CANNINGTON AFFORDABLE HOUSING FOR SENIORS

ADDENDUM NO: 8

Clarification No 1 (Structural)

- 1. Drawing SK-1 and SK-2
 - a. Shortened block wall along grid B at Stair No. 2.
 - b. Deleted block wall and replaced with wall type W4 along grid B, between grid 3 & 4.

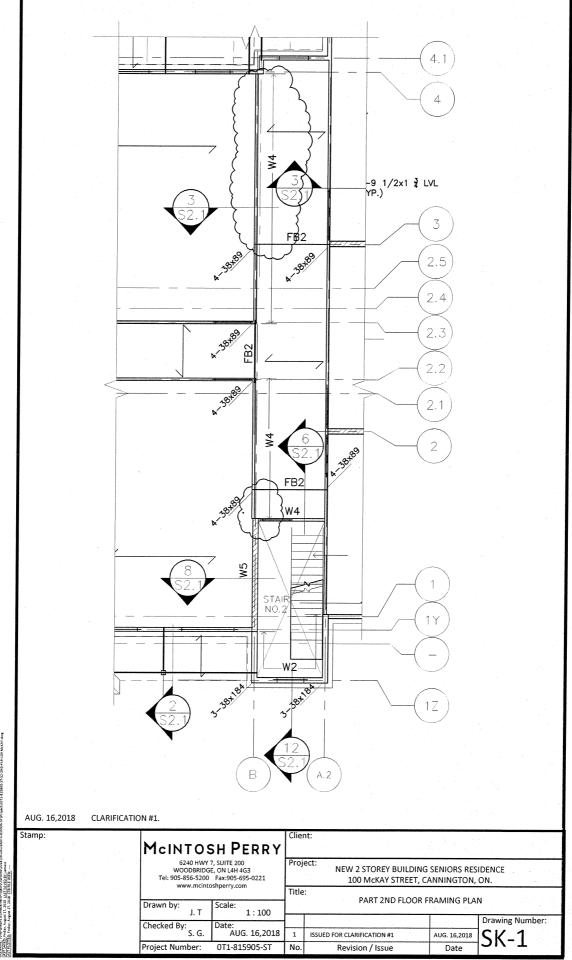
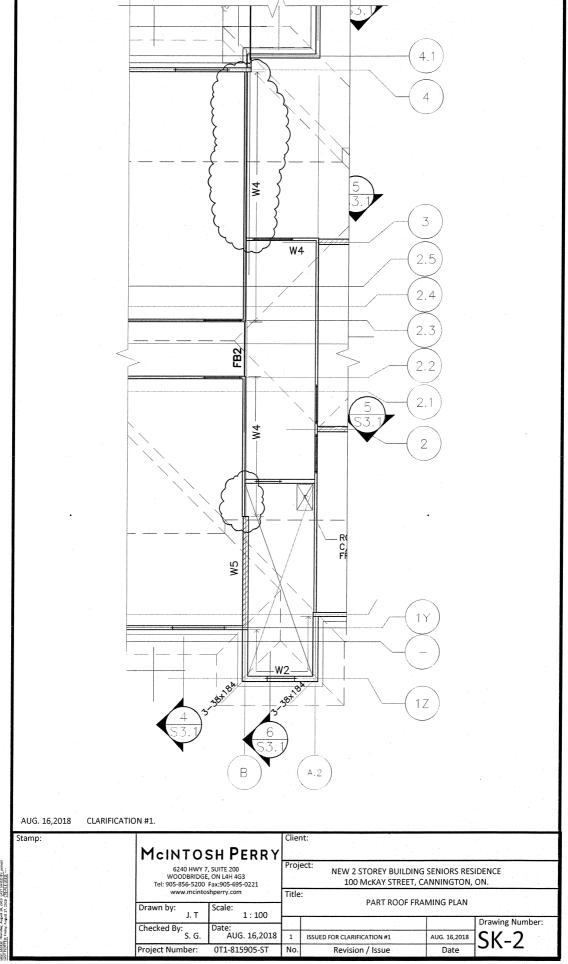
1. Clarifications have been attached for Structural Addendum No.1. The block walls along grid line B have modified as noted on Drawings Sk-1 and Sk-2.
